Addendum Addenda

Project Description / Description de projet	
S77 4th floor Process Steam Boiler/ Chaudière à vapeur de procédé au 4e étage	
Project No./No de projet	Departmental Representative / représentant ministériel
6092	Eric Poirier
Solicitation No./N° de sollicitation	
22-58138	
Notice: This addendum shall form part of the tender documents and all conditions shall apply and be read in conjunction with the original plans and specifications.	
Nota: Cet addenda fait partie intégrale des dossiers d'appel; toutes les conditions énoncées doivent être lues et appliquées en conjonction avec les plans et les devis originaux.

PROJECT NAME	100 SUSSEX DR. - NRC BUILDING S77 - 4TH FLOOR STEAM BOILER - CNRC BÂTIMENT S77 - CHAUDIÈRE À VAPEUR DU 4ÈME ÉTAGE PROJECT/PROJET NO. 6092
PROJECT NO.	GWAL 2022-471
DATE	MARCH 6, 2023
ADDENDUM NO.	ME1
<p>The following additions, deletions & revisions form part of the drawings and specifications for the above referenced project: Les ajouts, suppressions et révisions suivants font partie des dessins et des spécifications pour le projet susmentionné:</p>

CLIENT NRC			
PROJECT S77 6092 PROCESS STEAM BOILER	1688 Woodward Dr. Ottawa Ontario Canada K2C 3R

dwg.no. **6092-E02** dessin no.

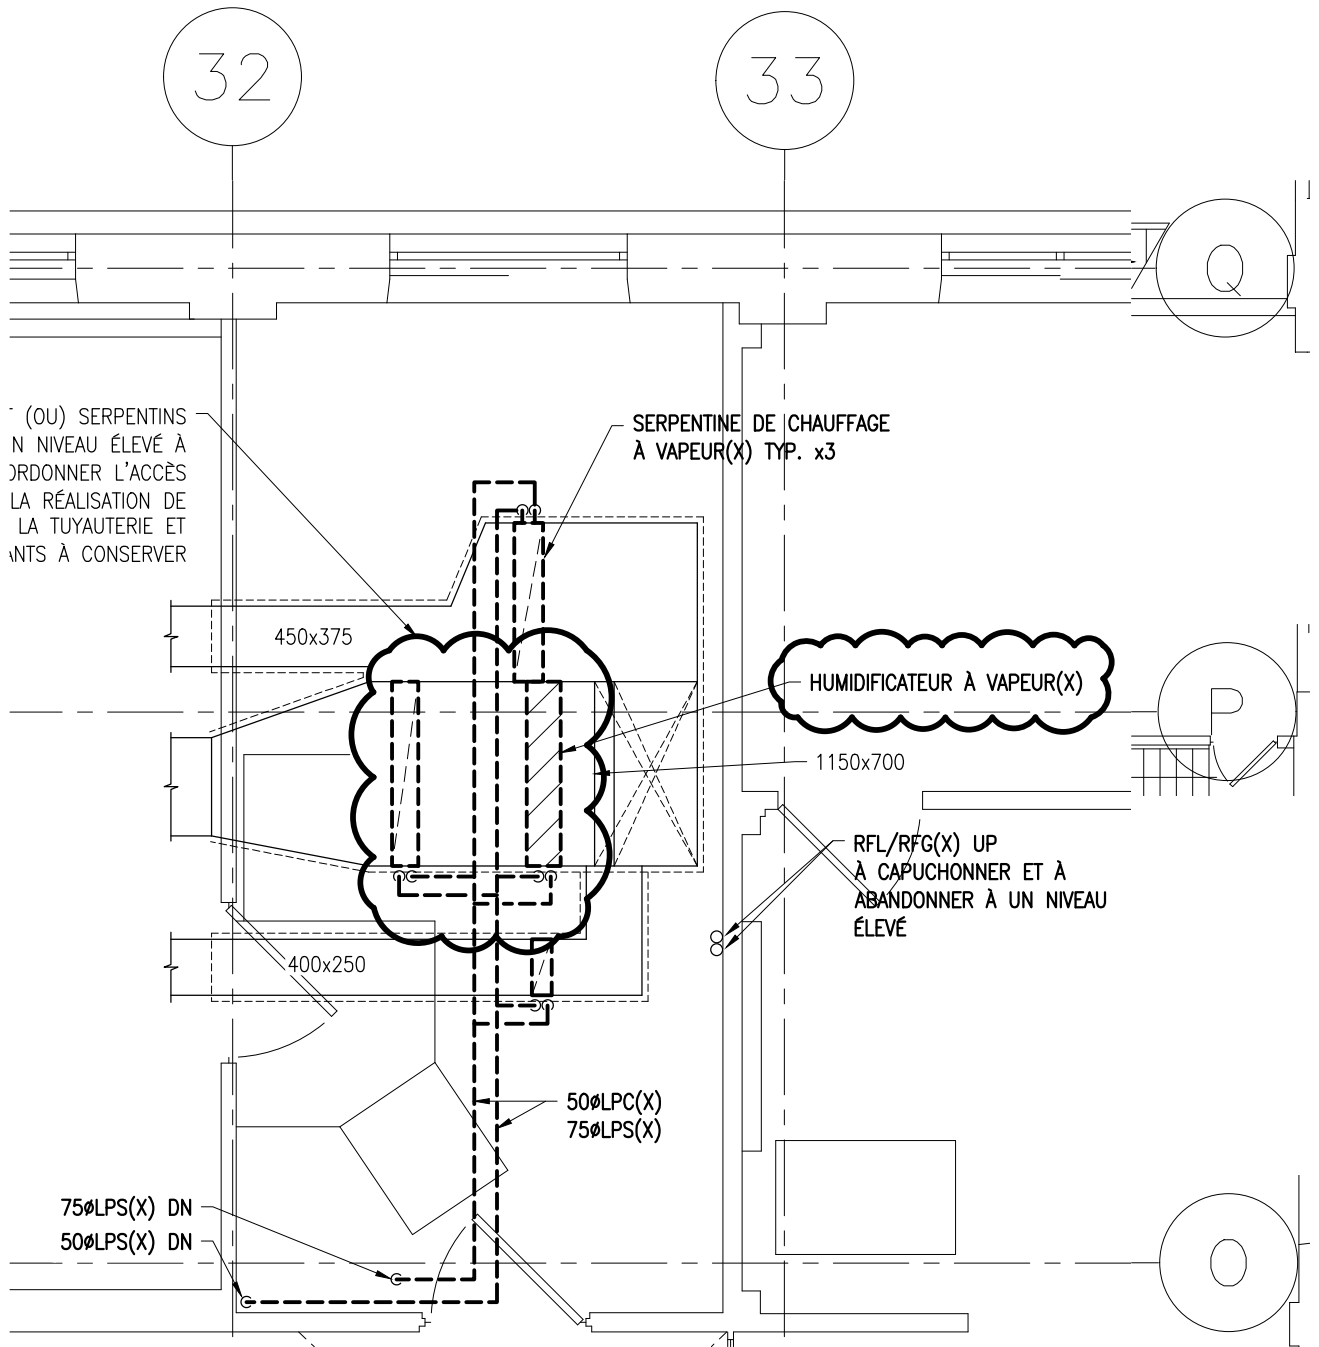
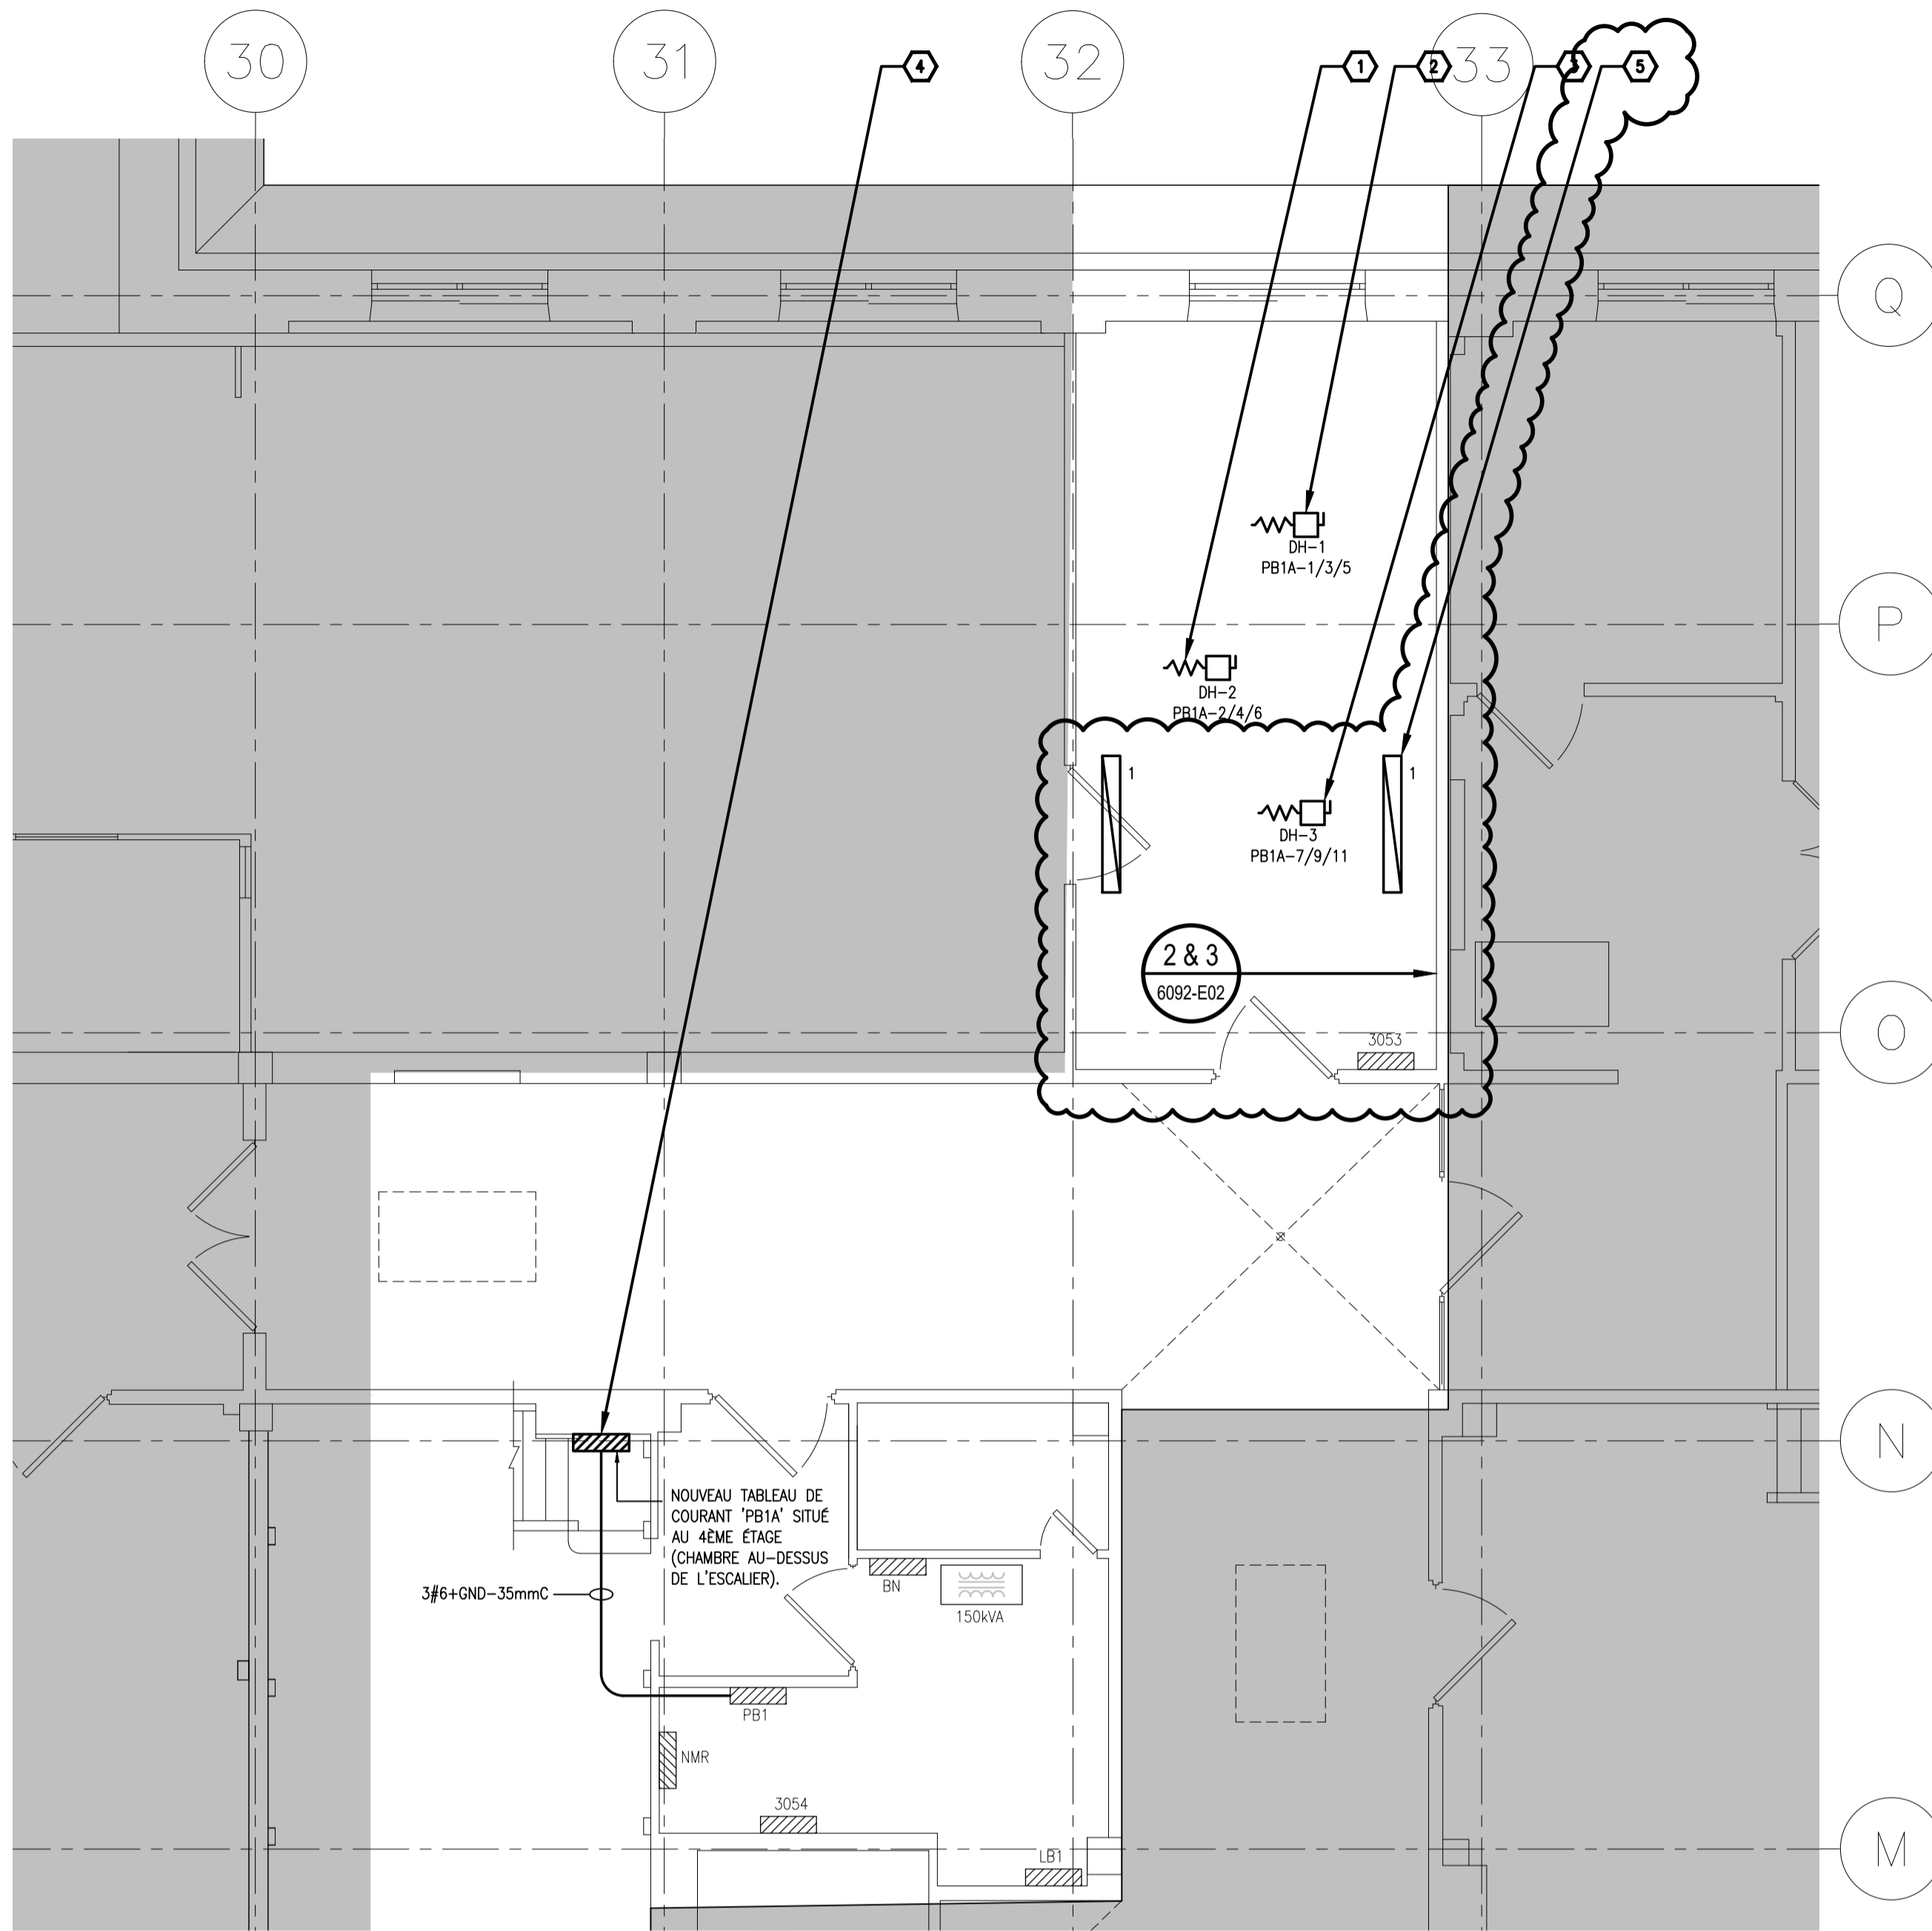
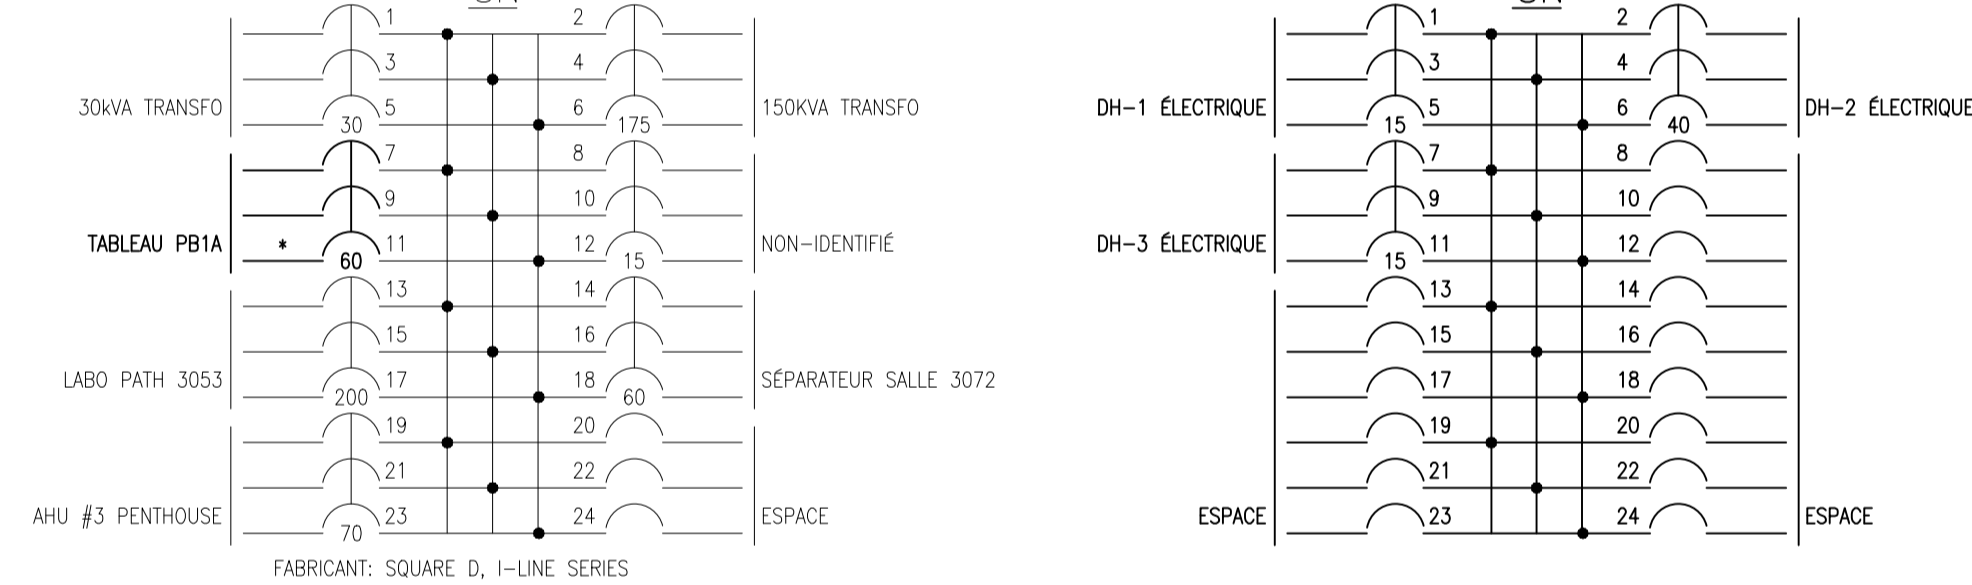
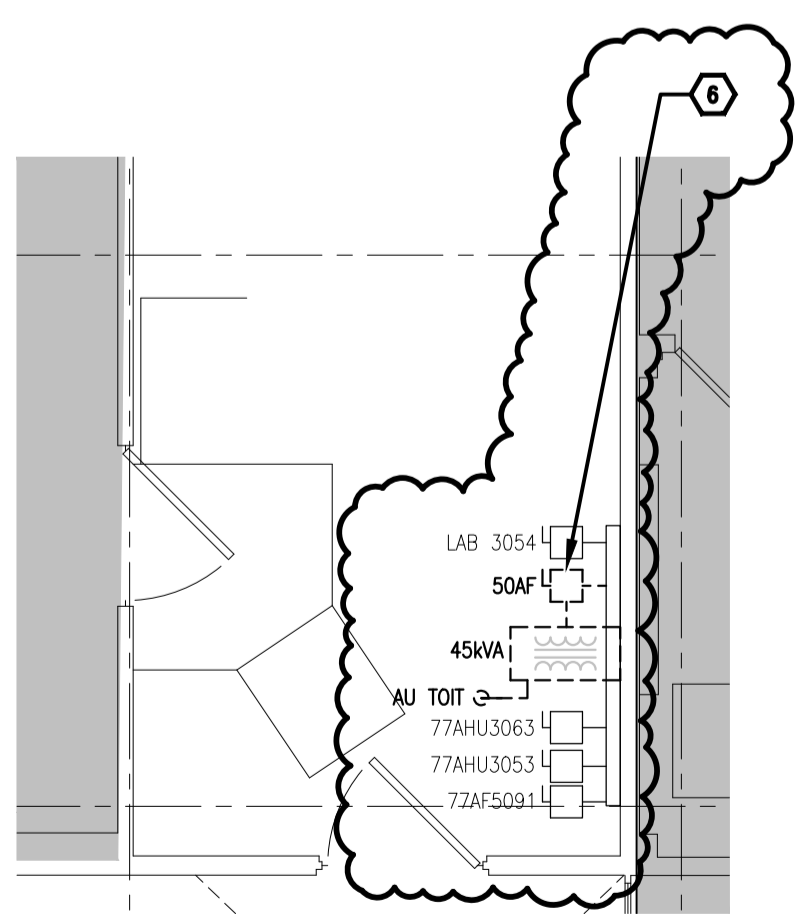
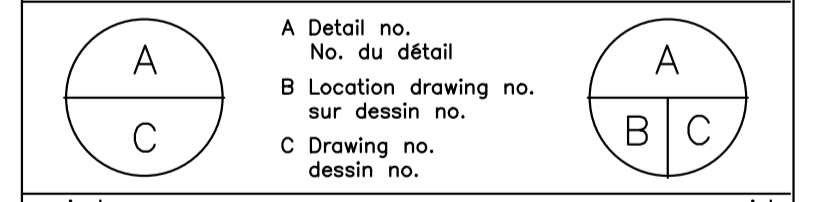
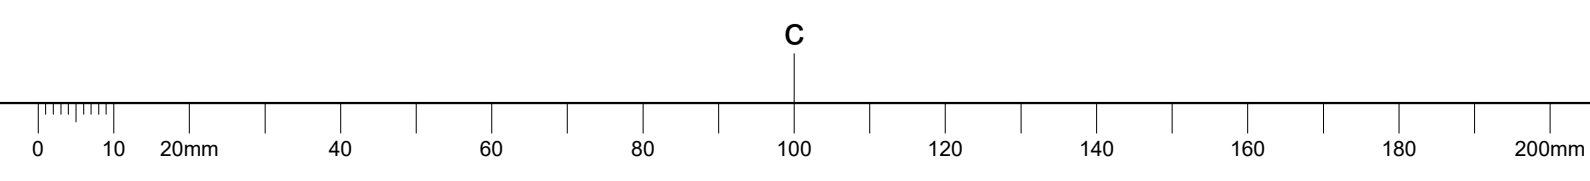
- PROVIDE CONNECTION TO NEW 600V, 3-PHASE, 36kW ELECTRIC DUCT HEATER DH-2 C/W INTEGRAL DISCONNECT SWITCH SUPPLIED AND INSTALLED BY MECHANICAL TRADES. CONNECT TO INDICATED CIRCUIT. COORDINATE EXACT LOCATION ON SITE WITH MECHANICAL TRADES.

- PROVIDE CONNECTION TO NEW 600V, 3-PHASE, 9kW ELECTRIC DUCT HEATER DH-1 C/W INTEGRAL DISCONNECT SWITCH SUPPLIED AND INSTALLED BY MECHANICAL TRADES. CONNECT TO INDICATED CIRCUIT. COORDINATE EXACT LOCATION ON SITE WITH MECHANICAL TRADES.

- PROVIDE CONNECTION TO NEW 600V, 3-PHASE, 6kW ELECTRIC DUCT HEATER DH-3 C/W INTEGRAL DISCONNECT SWITCH SUPPLIED AND INSTALLED BY MECHANICAL TRADES. CONNECT TO INDICATED CIRCUIT. COORDINATE EXACT LOCATION ON SITE WITH MECHANICAL TRADES.

- PROVIDE NEW 600V, 3-PHASE, 60A, 24 CIRCUIT SURFACE MOUNT ELECTRICAL PANEL ON 4TH FLOOR ABOVE STAIRWELL AS SHOWN. REPLACE EXISTING 40A, 3-POLE BREAKER IN PANEL 'PB1' LOCATED IN ROOM 3054 WITH NEW 60A, 3-POLE BREAKER. PROVIDE NEW 3#6+GND-35mmC FEEDER AS SHOWN. PROVIDE CORING AND FIRESTOP ALL PENETRATIONS.

- TEMPORARILY DISCONNECT AND REMOVE (2) EXISTING 1,220mm SUSPENDED FLUORESCENT STRIP LIGHT FIXTURES TO ACCOMMODATE MECHANICAL WORK. RE-INSTATE UPON COMPLETION OF WORK. EXTEND CONDUIT AND WIRING AS REQUIRED. COORDINATE EXACT LOCATION ON SITE.

- DISCONNECT AND REMOVE EXISTING WALL MOUNTED 600V, 50AF DISCONNECT SWITCH AND EXISTING 600-120/208V, 3-PHASE, 45kVA TRANSFORMER FEEDING REDUNDANT CONDENSER UNIT ON THE ROOF. DISCONNECT AND REMOVE ALL ASSOCIATED WIRING AND CONDUIT UP TO ROOF SLAB AND MAKE SAFE. COORDINATE EXACT LOCATION ON SITE.
